Alternative Hardware Explained:

Rear view showing the alternative hardware version of the AudioNav

The diagrams below show the rear view of the 'original' AudioNav installed using option A and option B.

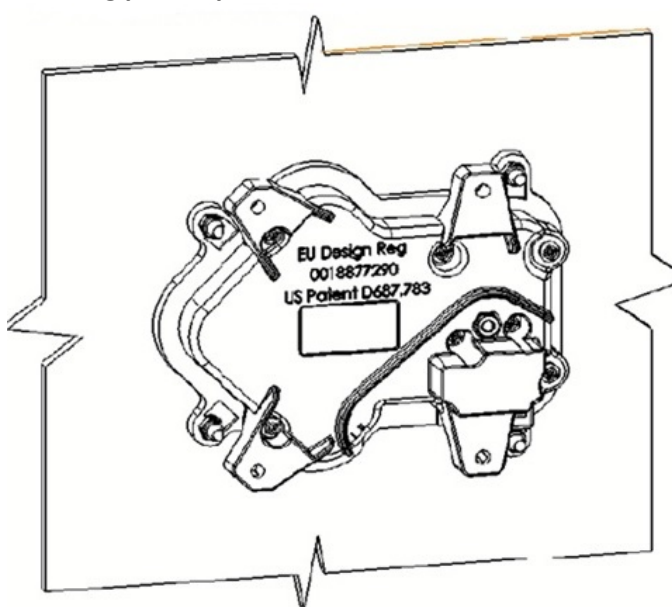
The 'original' AudioNav includes two sets of fixing bosses.

Fixing points, position A

Fixing points, position B

Fixing points, position B – no change required

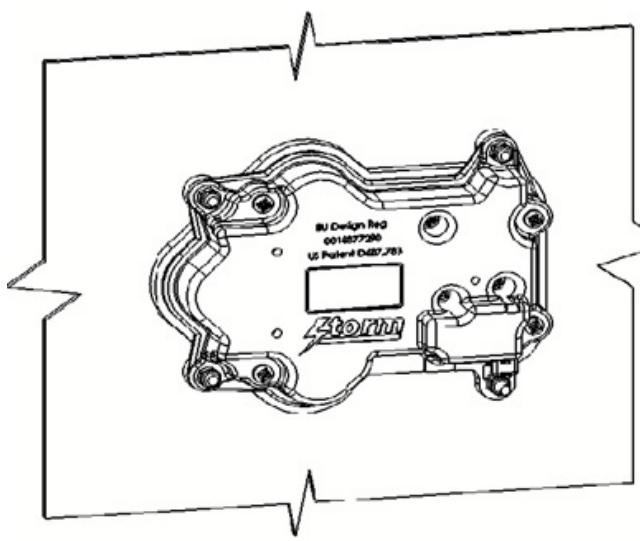
Fixing Position B still requires M3 x 12 mm studs.

Note that the bosses are now 7mm thick
(was 4mm previously)

On the alternative hardware version the cable tie is supplied fitted
